STATE OF CONNECTICUT  
CONNECTICUT SITING COUNCIL

APPLICATION OF MESSAGE CENTER  
MANAGEMENT, INC. (MCM) AND NEW CINGULAR  
WIRELESS (AT&T) FOR A CERTIFICATE OF  
ENVIRONMENTAL COMPATIBILITY AND PUBLIC  
NEED FOR THE CONSTRUCTION, MAINTENANCE  
AND OPERATION OF A TELECOMMUNICATIONS  
TOWER FACILITY IN REDDING, CONNECTICUT

DOCKET NO. 449

RESPONSES OF MESSAGE CENTER MANAGEMENT  
AND NEW CINGULAR WIRELESS  
TO CONNECTICUT SITING COUNCIL PRE-HEARING QUESTIONS, SET I

ATTACHMENT 5

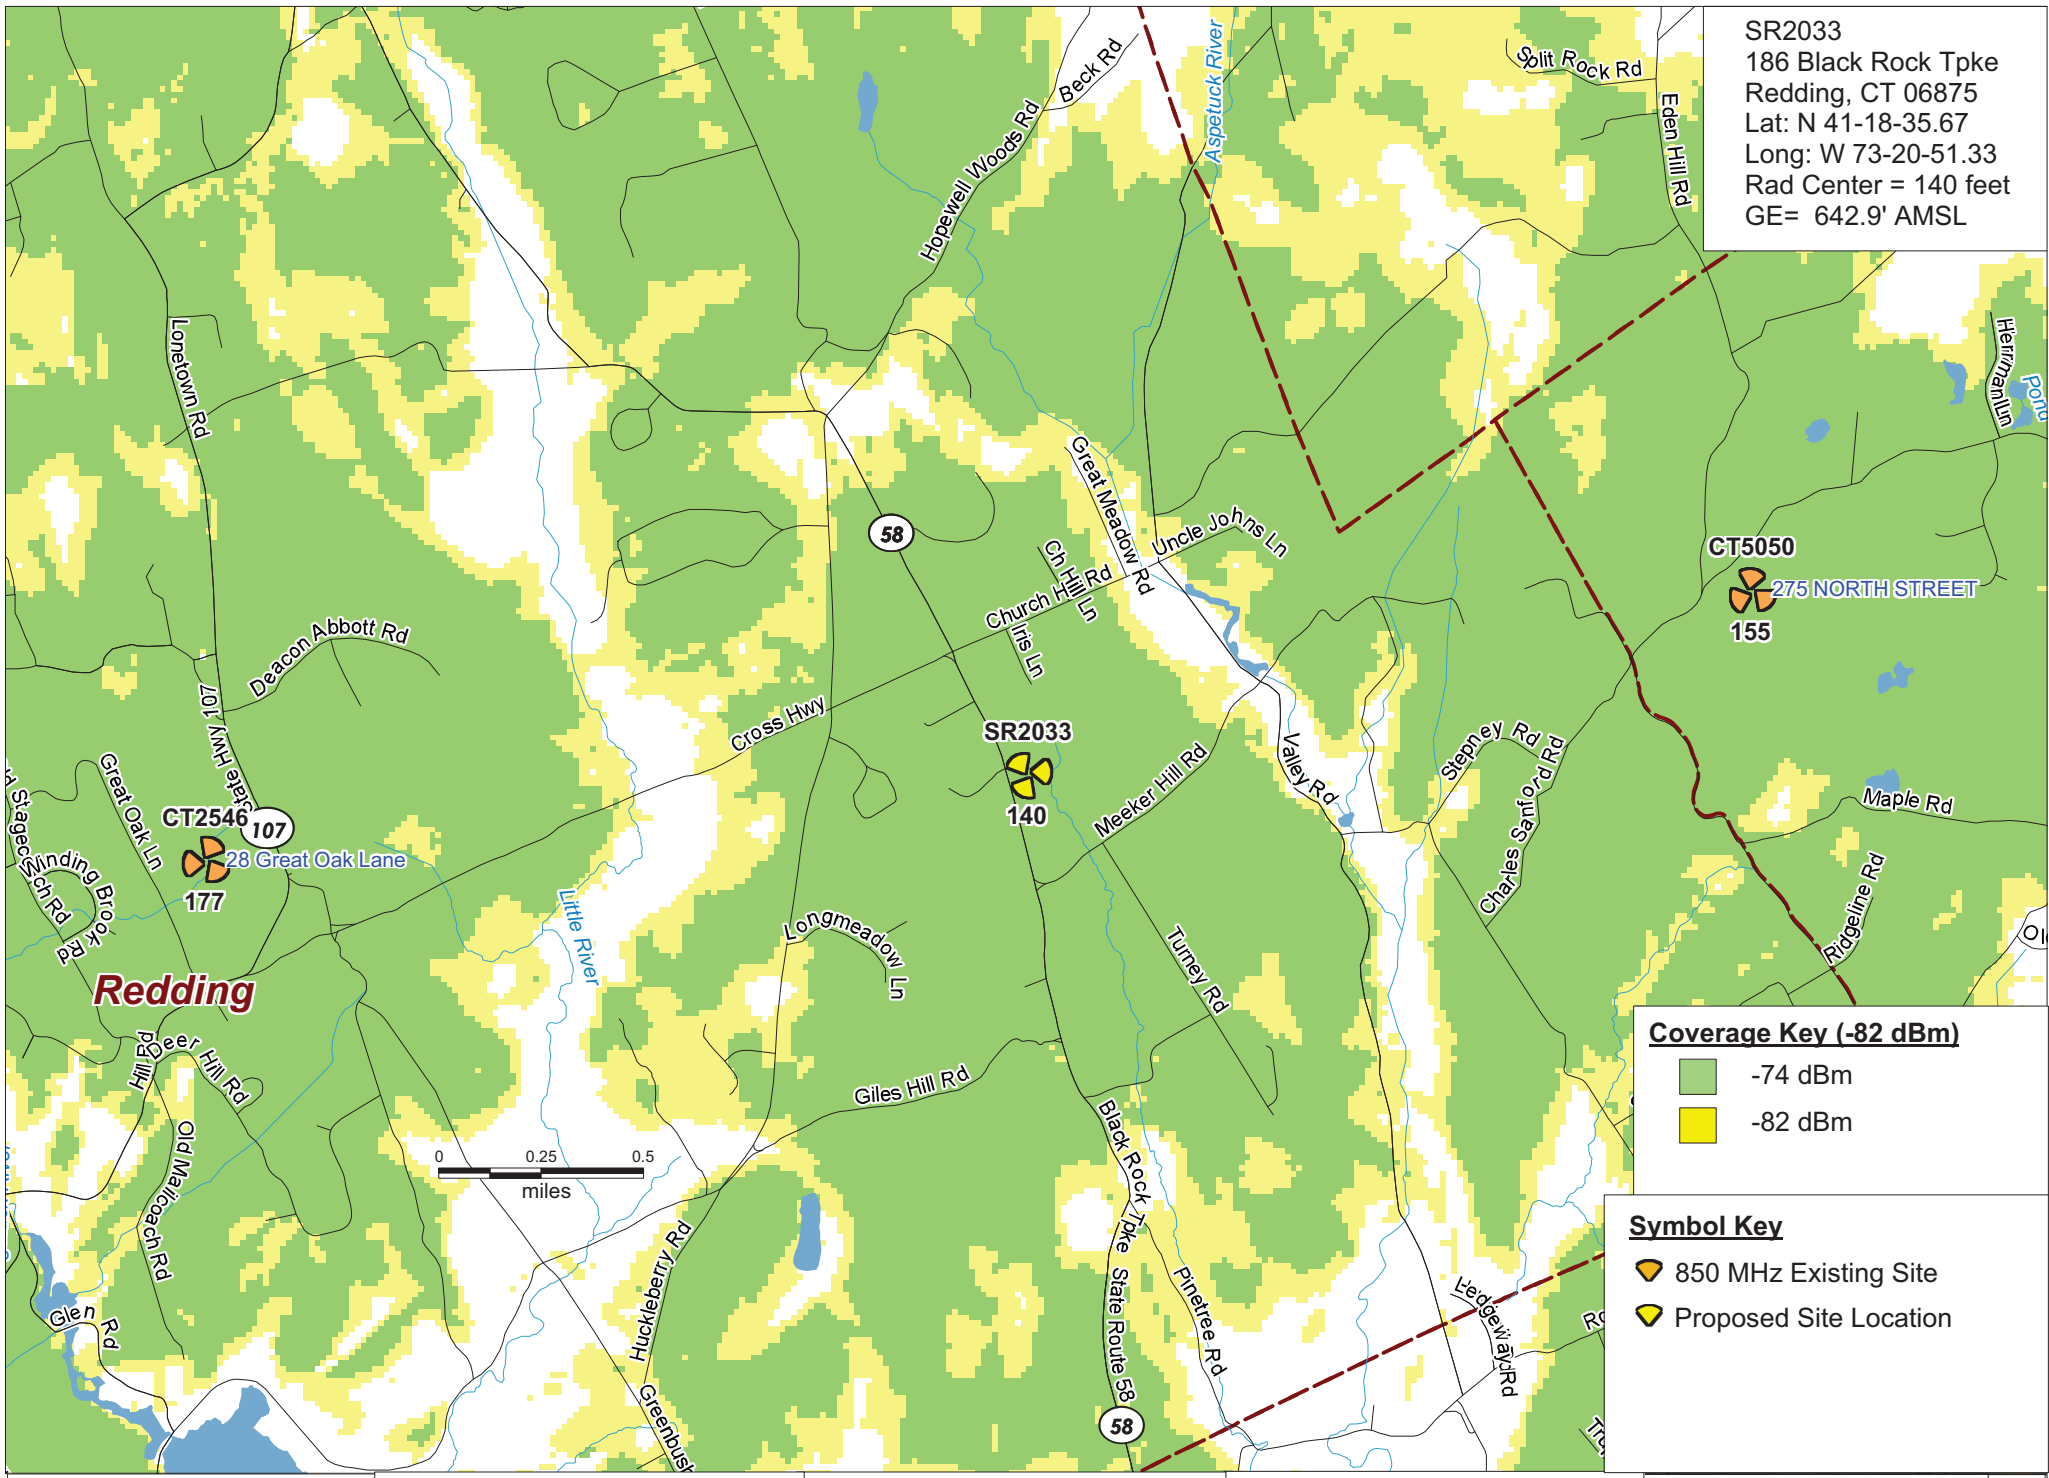
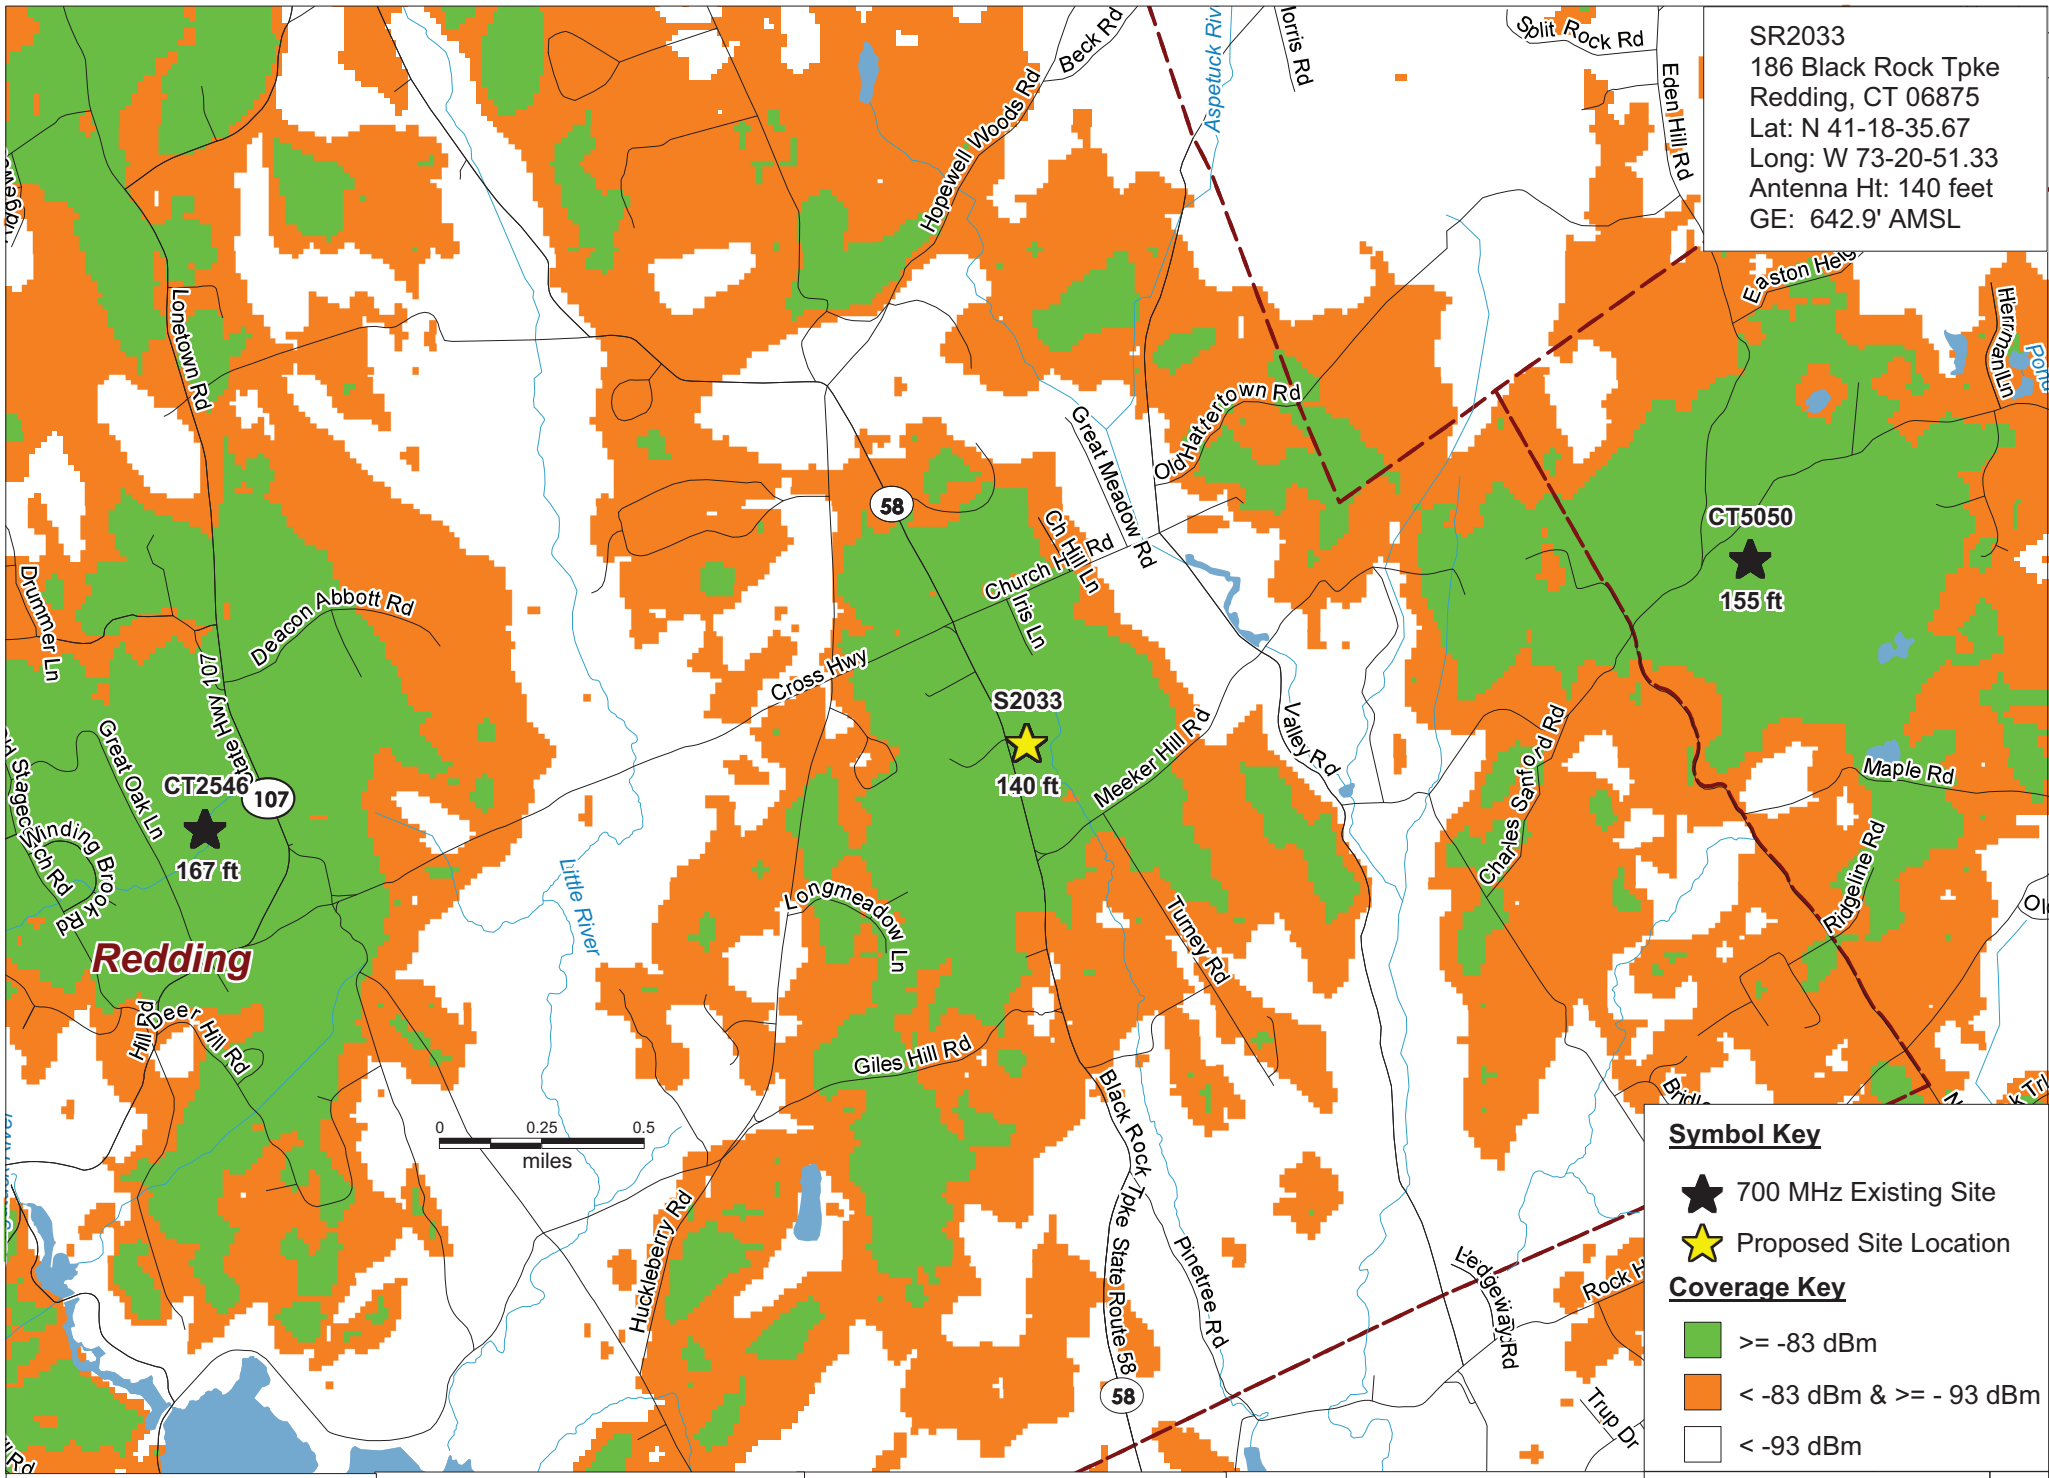
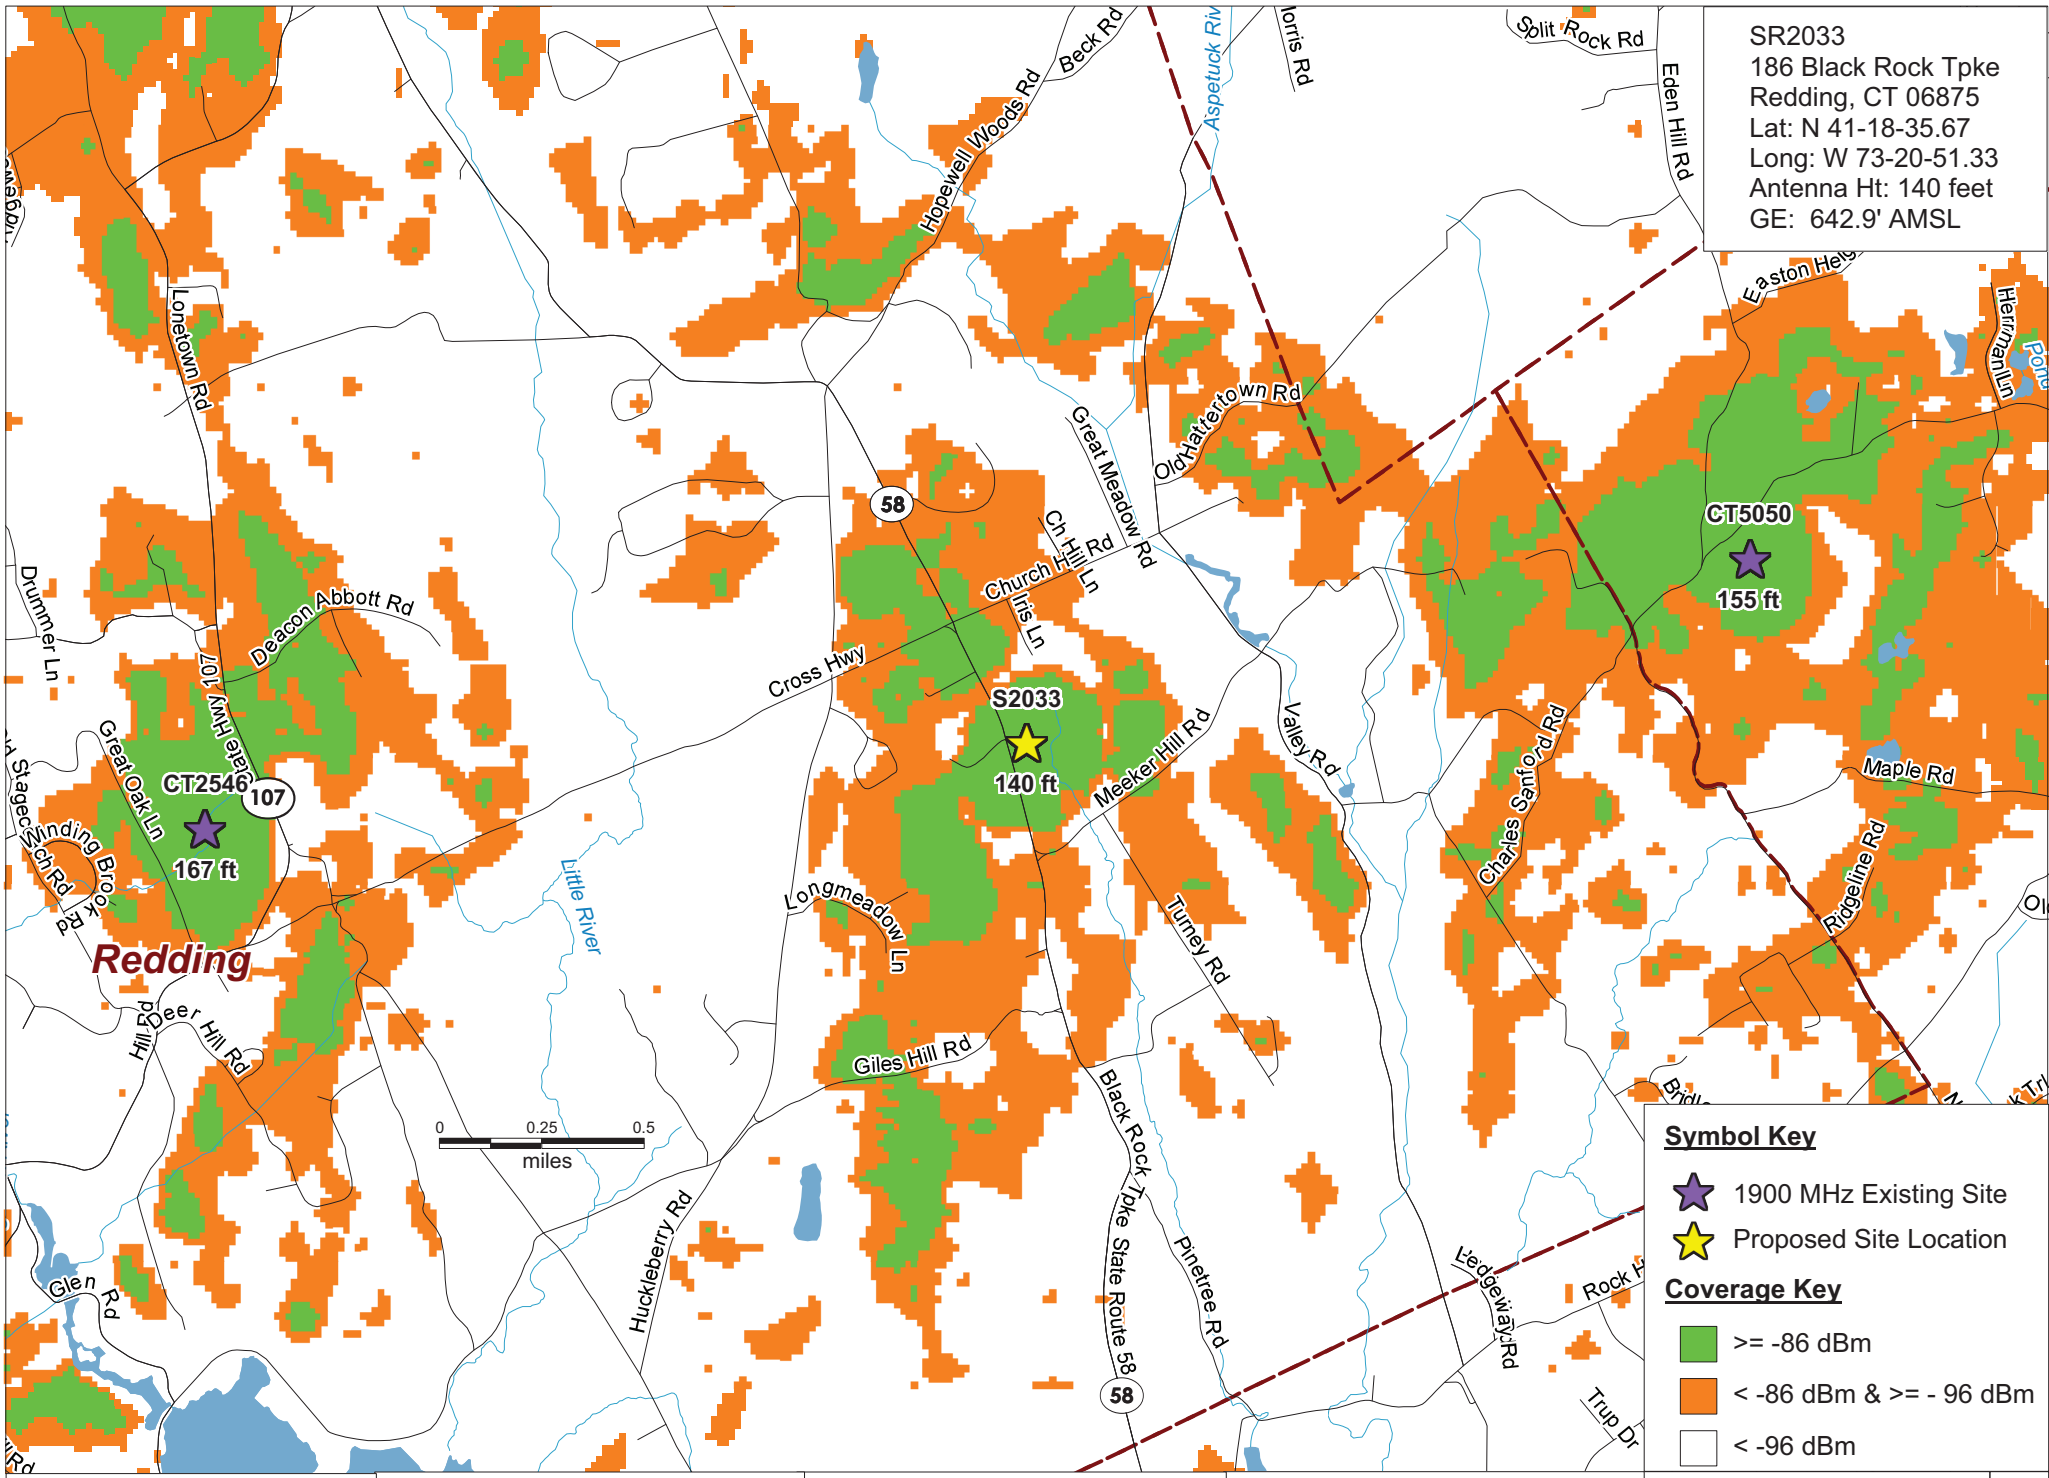
Q29. Provide propagation maps showing existing plus proposed coverage at an antenna height that is ten feet shorter than proposed for 700 MHz, 850 MHz, and 1900 MHz or as applicable.

A29. Please see Attachment 5.
